**City of Bellevue
Development Services Department
Land Use Staff Report**

Proposal Name: Yu 130 Short Plat

Proposal Description: Preliminary Short Plat approval to subdivide an existing parcel into two single family lots within the R-5 zoning district.

File Number: 15-116984-LN

Figure 1 – Preliminary Short Plat Proposal

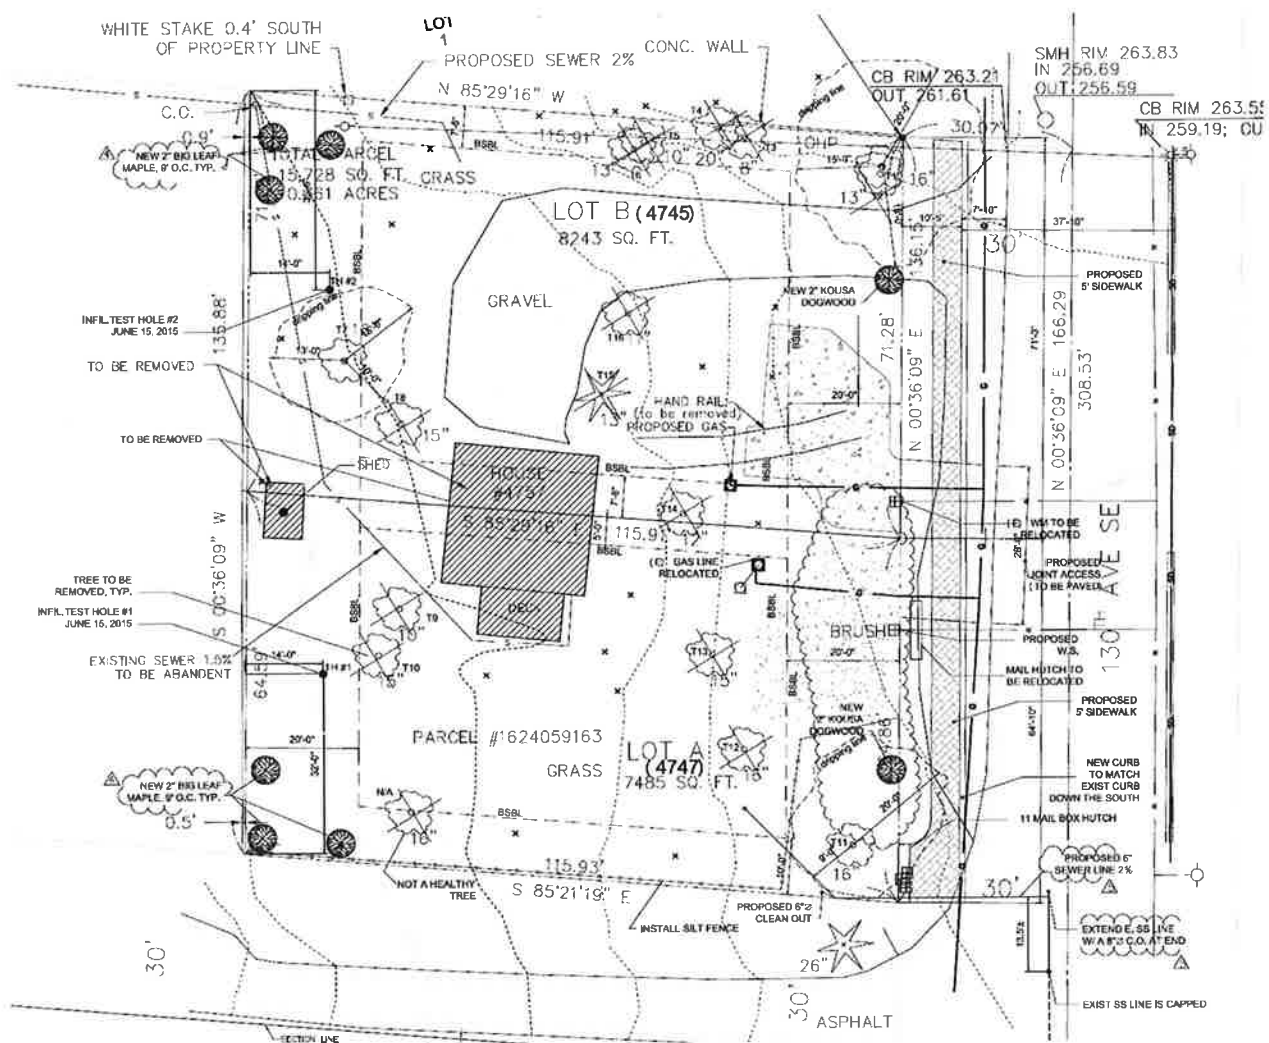
The original submittal dated September 1, 2015 proposed no retention of existing trees. The applicant was made aware of the City's code as it relates to tree retention and revised the plan to retain 41 diameter inches of existing trees. The applicant submitted an alternative landscaping plan for the remaining 8" of required tree retention as allowed per LUC 20.20.900.G.2.

The original design was revised to retain more significant trees and individual driveways were combined into a joint access easement off 130th Ave SE

- a) Site Specific Items:
 - i. The construction of the joint-use driveway with a maximum width of 28 feet contained within a 30 foot access easement. The joint-use driveway connects to 130th Avenue SE and no other access connection to the city right-of-way is authorized.
 - ii. The installation of a five foot wide sidewalk with curb, gutter, and storm drainage system and pavement widening for the full length of the project site street frontage, matching the street cross section along 130th Avenue SE just north of SE 48th Place. The pavement and subgrade depths shall be shown in Standard Drawing DEV-9.
 - iii. Where the new concrete sidewalk ends at the south end of the subject

- iv. A driveway apron for the connection of the joint-use driveway to 130th Avenue SE is required and shall be per Standard Drawing DEV-7A.
- v. Sight distance setback lines shall be shown on the civil engineering plans at the joint-use driveway as exhibited in Standard Drawing TE-1 and TE-3.
- vi. The mailbox installation location will be shown on the civil engineering plans as determined with the Bellevue Post Master.
- vii. The minimum pavement grind and overlay requirement for 130th Avenue SE, will be a minimum of half roadway (show on civil engineering plans) and as specified on the Right of Way Use Permit and by the Transportation Construction Inspector.
- viii. Restore thermoplastic pavement channelization as needed to match the existing fog line to the north of the subject property.
